CITY OF ALBUQUERQUE

**Re: Fiesta Subaru
7100 Lomas Blvd NE
Traffic Circulation Layout
Engineer's Stamp 02-21-2022 (K18-D108A)**

Based upon the information provided in your submittal received 03-01-2022, the above referenced plan cannot be approved for Building Permit until the following comments are addressed:

TCL-1

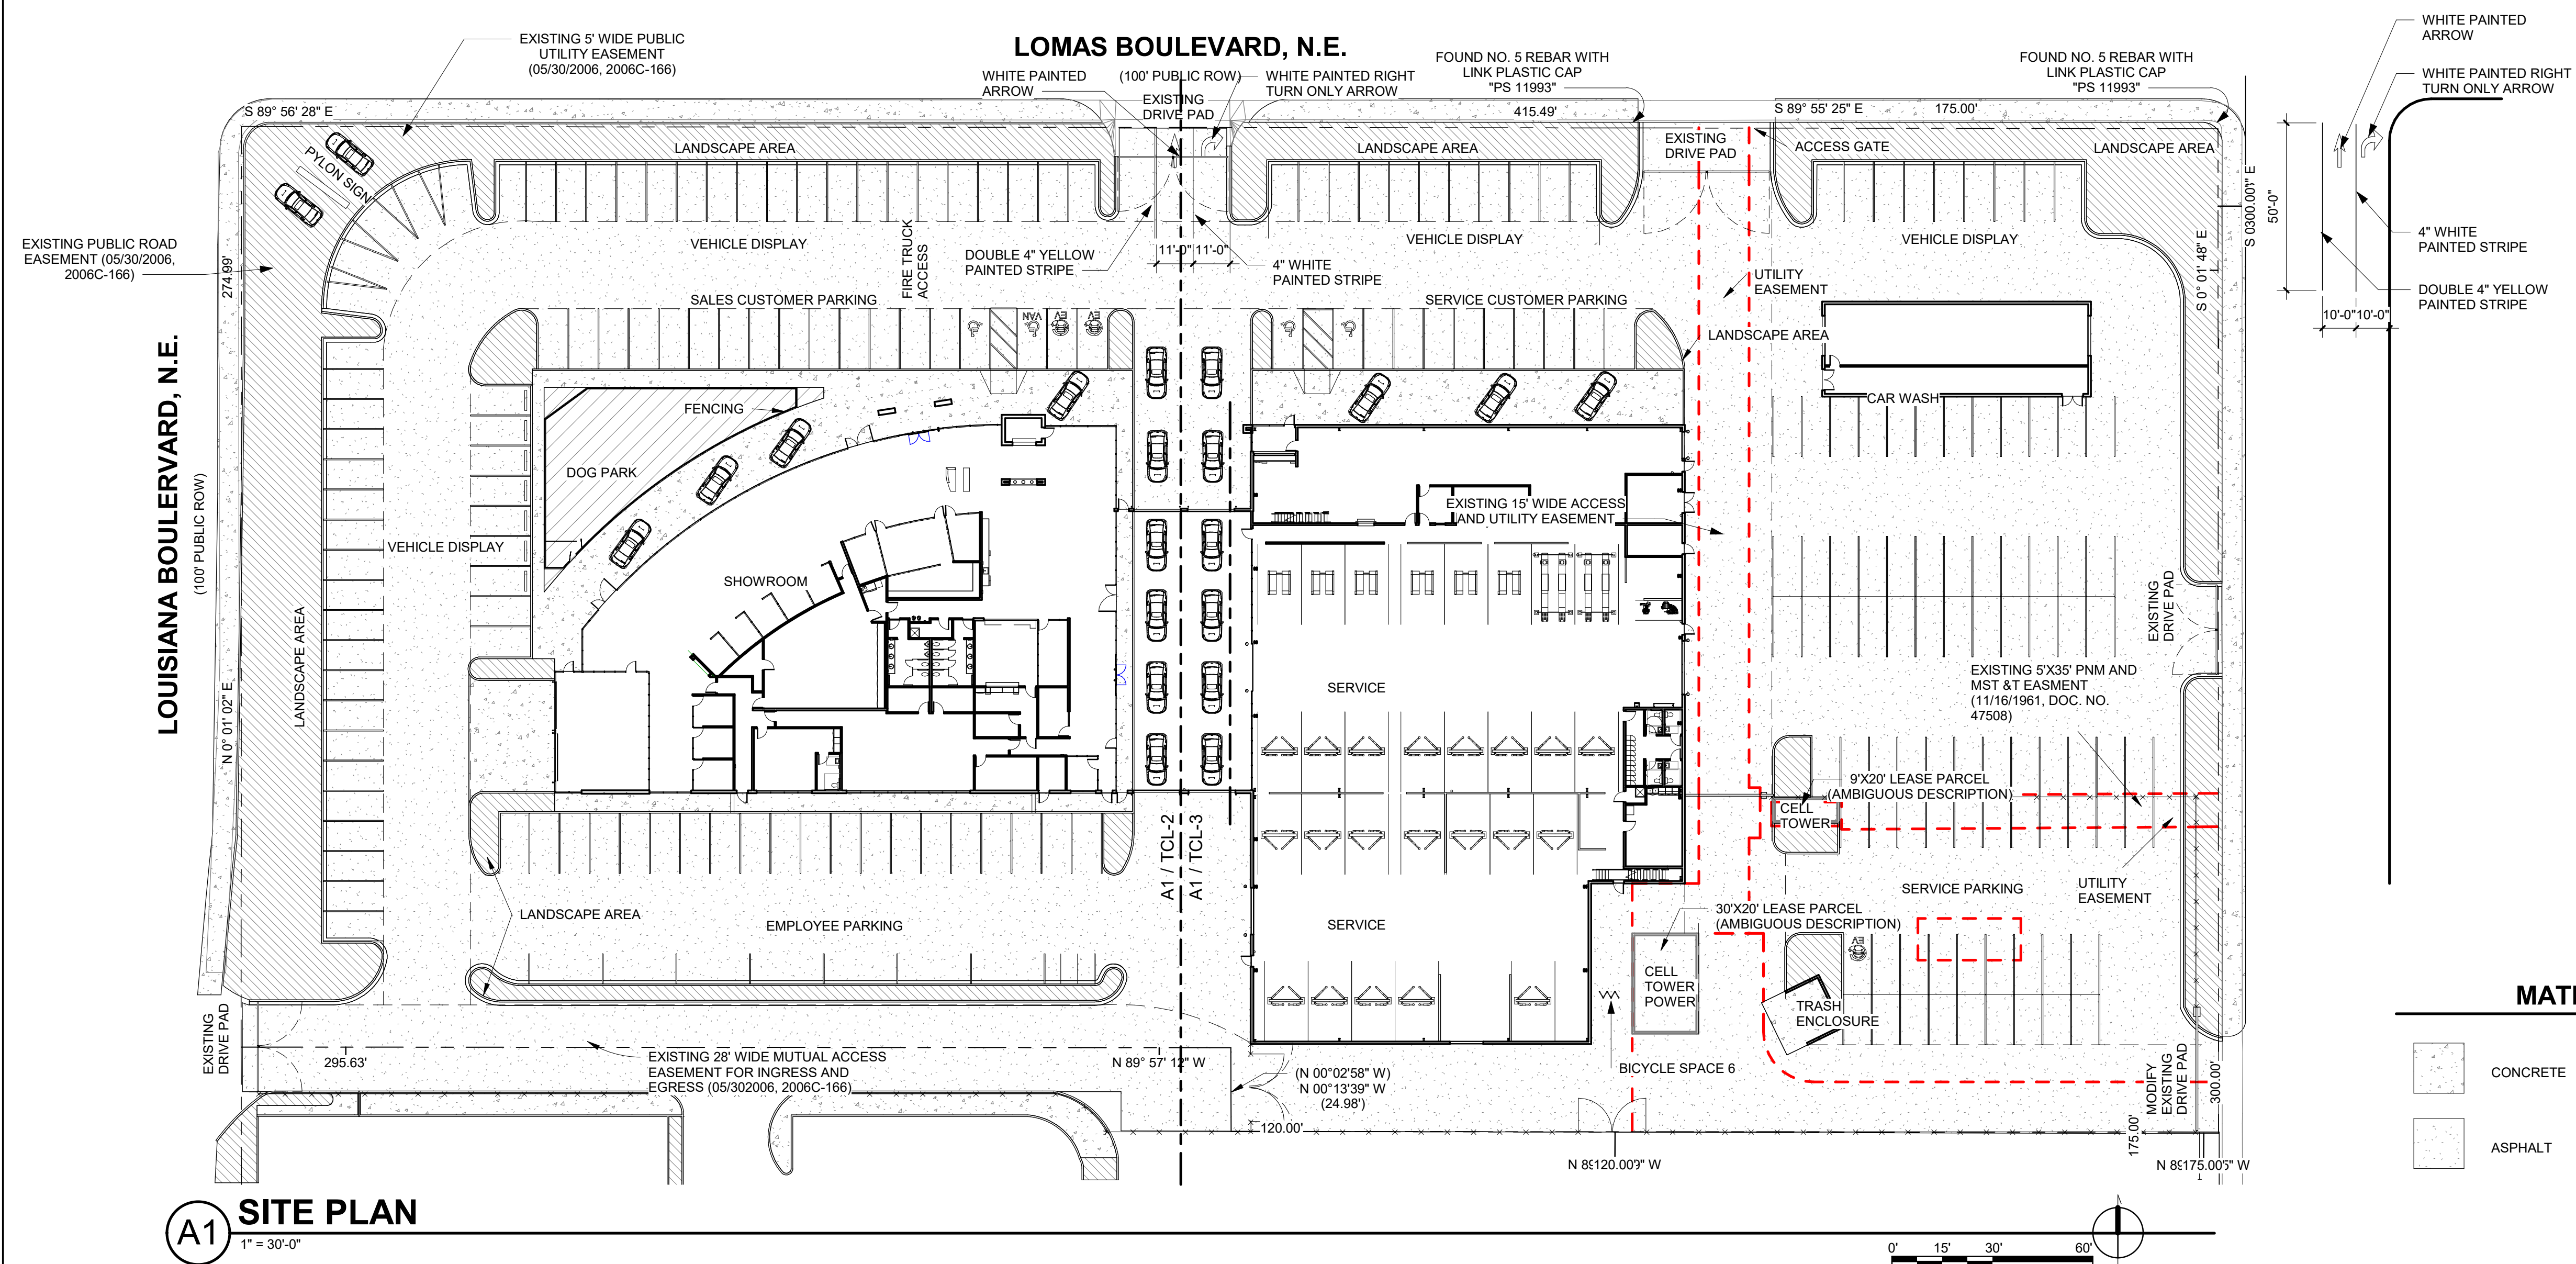
1. Listed are the number of Bicycle parking spaces required by the IDO
Coordinate/discuss with Zoning.
2. **Louisiana/Lomas:**
 - The Minimum Throat depth off an Arterial needs to be comply, please review DPM Design Criteria Table 7.4.81 **Minimum Throat Length.**

3. An ADA ramp will need to be provided at the corner of Louisiana/Lomas. The existing ramp doesn't provide a minimum pathway width of 4 ft to service ADA prior to ramp landing.

4. All existing driveways off Louisiana and Lomas are not ADA accessible. So they will need to be ADA accessible and the design will need to be Curb Return since both roadways are classified as Arterial.

5. Please label the name of side street on the eastern property. **Chama?**
6. Identify the right of way width, medians, curb cuts, and street widths on Chamas st. NE

7. Provide details for all proposed pavement markings.
8. Chamas existing driveway aren't ADA accessible and will need to be addressed.
9. Louisiana's, Lomas's and Chama's main access with proposed gates will need a setback of 20 feet to provide turnout.

10. A sidewalk easement will be needed at the corner of Louisiana/Lomas to encompass the full size of new ramp.
11. Provide turning templates for delivery vehicle.

##- Provide all access widths for ingress/egress off all public roadway.

- d. The rack allows varying bicycle frame sizes and styles to be attached.
 - e. The user is not required to lift the bicycle onto the bicycle rack.
 - f. Each bicycle parking space is accessible without moving another bicycle.

16. Bicycle racks shall be sturdy and anchored to a concrete pad.
17. A 1-foot clear zone around the bicycle parking stall shall be provided.
18. Bicycle parking spaces shall be at least 6 feet long and 2 feet wide.

19. All internal radii's will need to be 15 feet.
20. Per the DPM, a 6 ft. wide ADA accessible pedestrian pathway is required from the public sidewalk to the building entrances. Please clearly show this pathway and provide details.

21. Per DPM, a 6 ft. wide ADA accessible pedestrian pathway is required from the ADA parking stall access aisles to the building entrances. Please clearly show this pathway and provide details.

22. All sidewalks along public streets need widths provided.
23. Parking areas shall have barriers to prevent vehicles from extending over onto pedestrian pathway.

A1 SITE PLAN

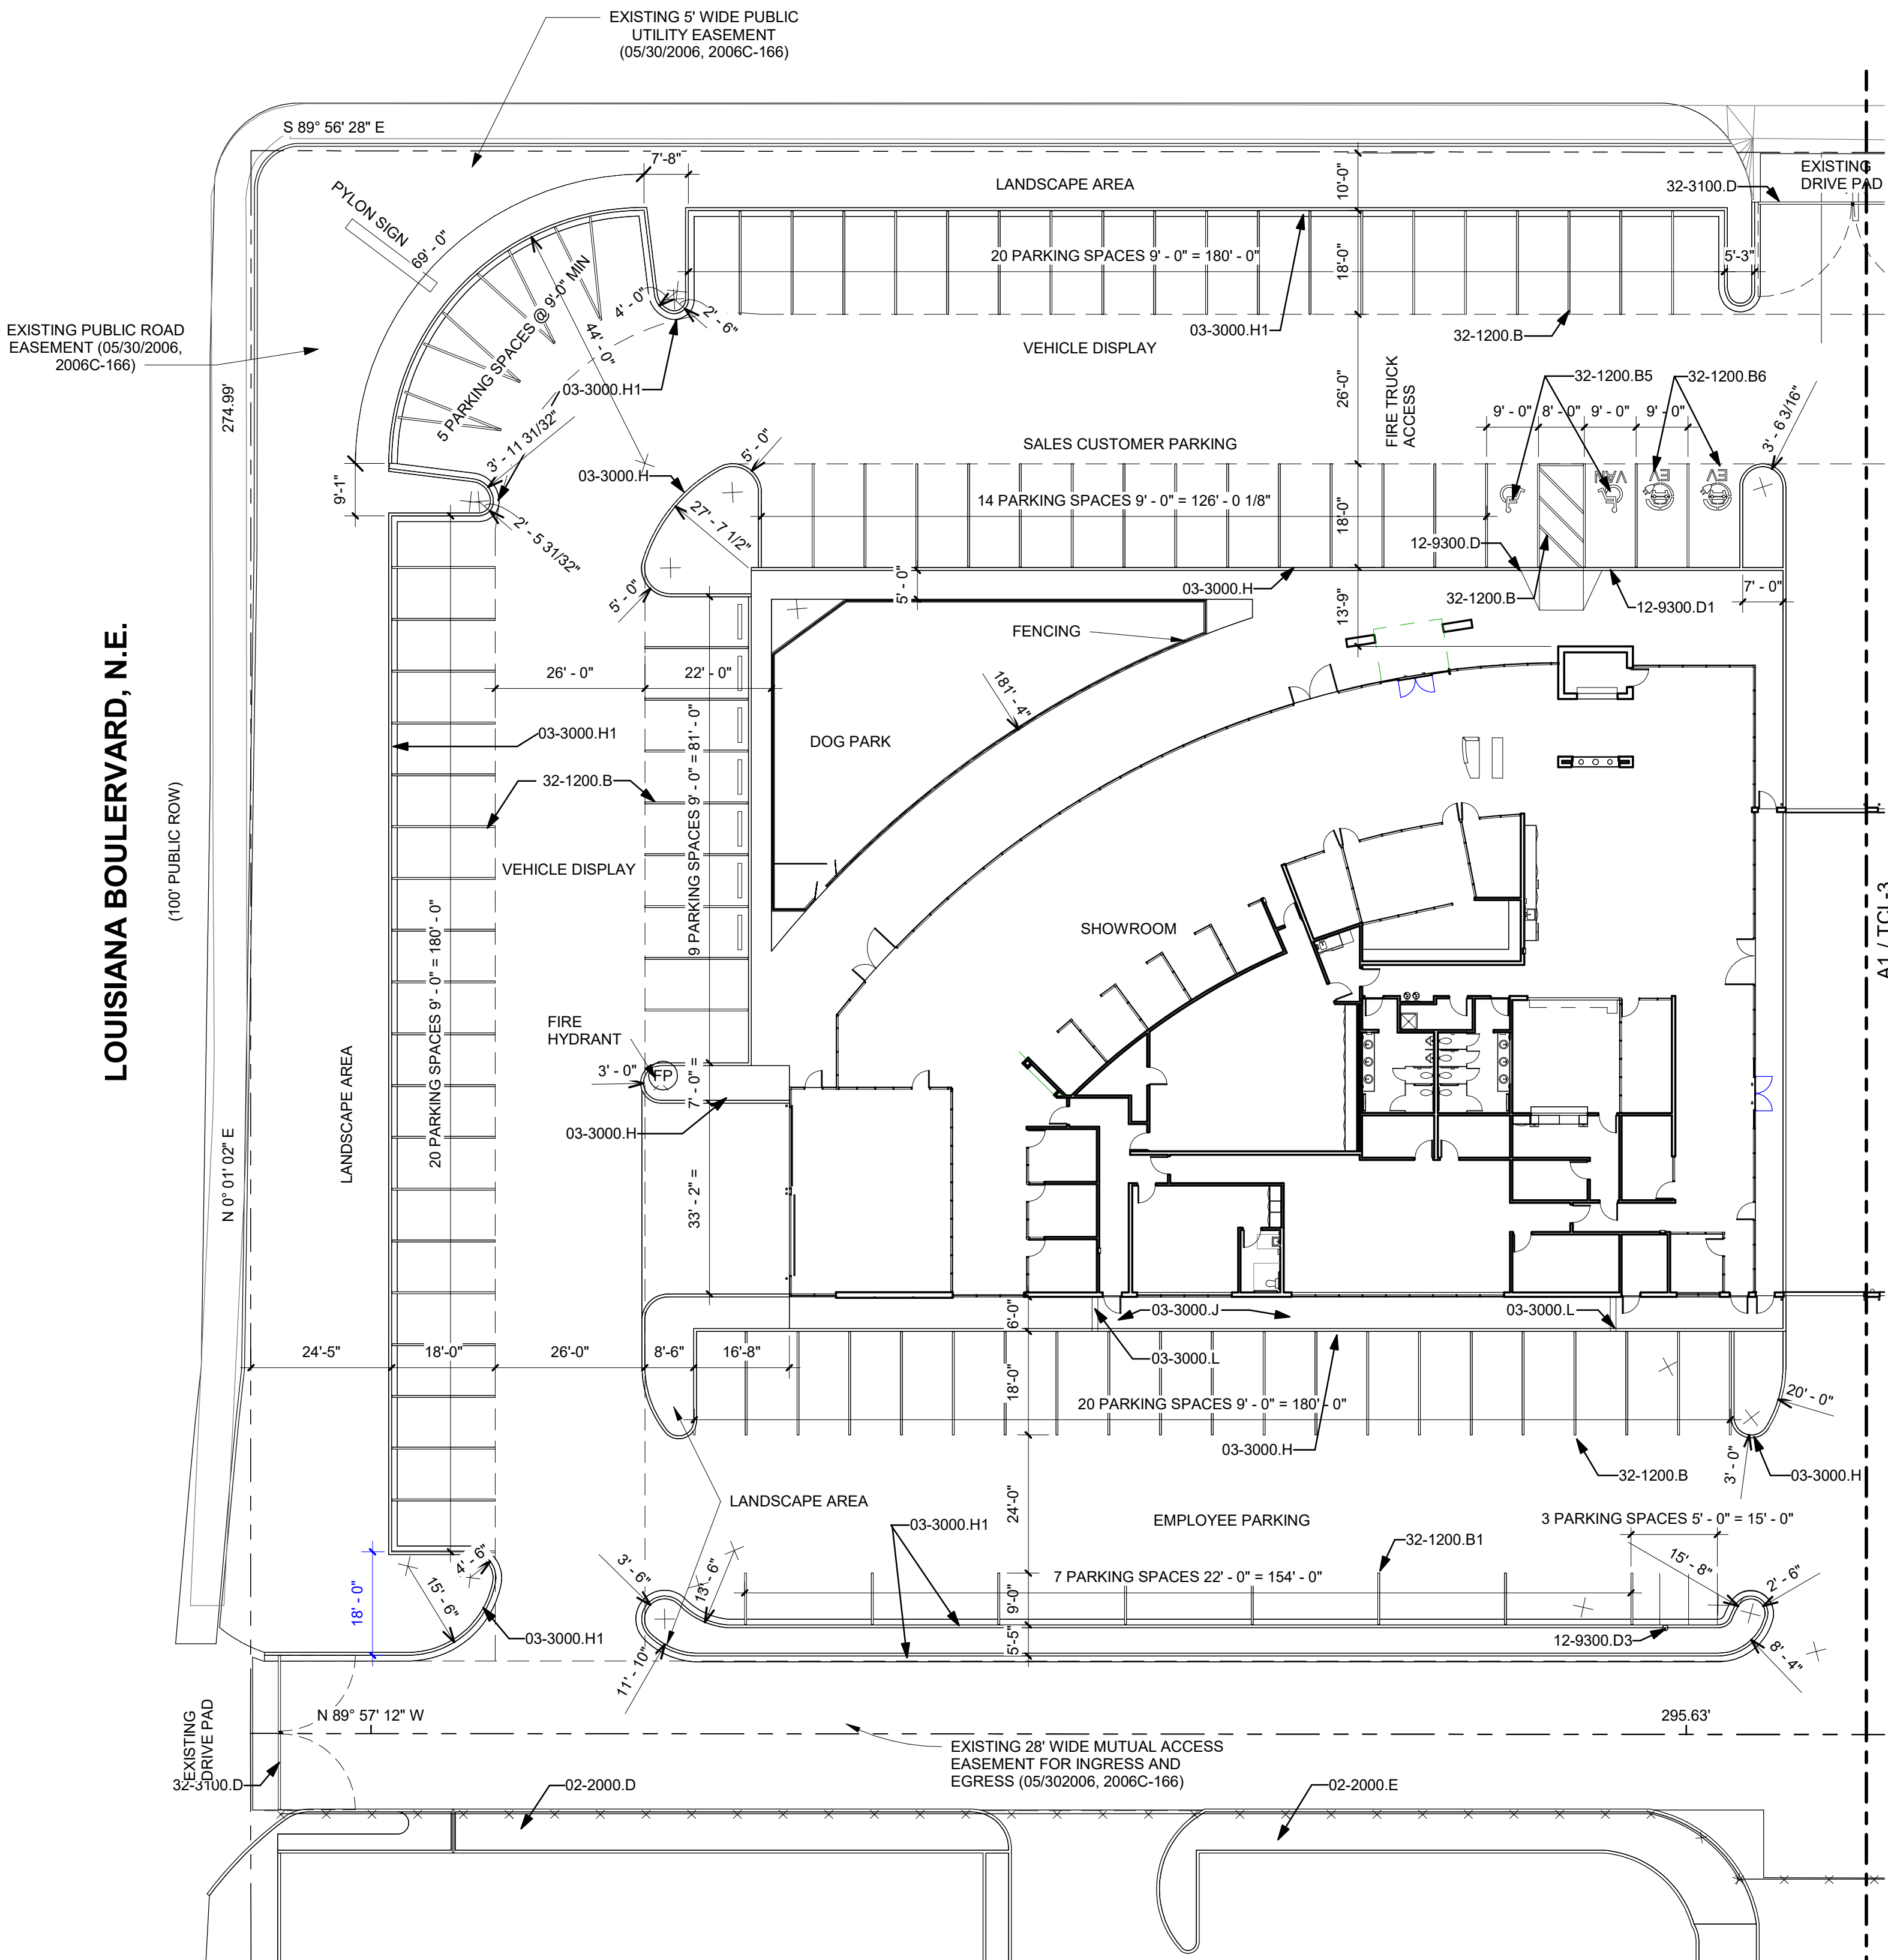
- Provide egress left turn lane instead of thru movement.
29. Louisiana midblock has a pole in middle of sidewalk. Reference COA std dwg 2431 to provide sidewalk transition. Also, will a sidewalk easement be needed for this proposed sidewalk transition to provide a 4 ft wide clearance around pole? Please address this concern.

30. Please specify the City Standard Drawing Number when applicable.
31. Shared Site access: driveways that straddle property lines, or are entirely on one property but are to be used by another property, shall have an access easement. **Please provide a copy of the Access Easement for all properties abutting general lot and entrance access off Louisiana.**

32. Unused curb cuts must be replaced with sidewalk and curb & gutter. A build note must be provided referring to the appropriate City Standard drawing (2430 & 2415A). **Two have been identified but not addressed off Louisiana.**
